Petition Number: 2019-098 General Location Identifier: 157016029

From: Felix Obregon, PE Reviewer: Eric Lemieux, PE

Date	Description	
08-21-19	First Review	
10-21-19	Second Review

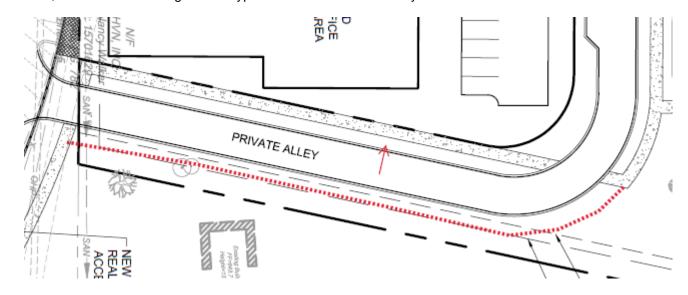
- 4. CDOT requests for the petitioner to revise the site plan and conditional note(s) to commit to constructing an 8-foot multi-use path from Sam Drenan to the future Briar Creek Greenway alignment, per CDOT's Greenway Masterplan, within a 10-foot wide greenway public easement.
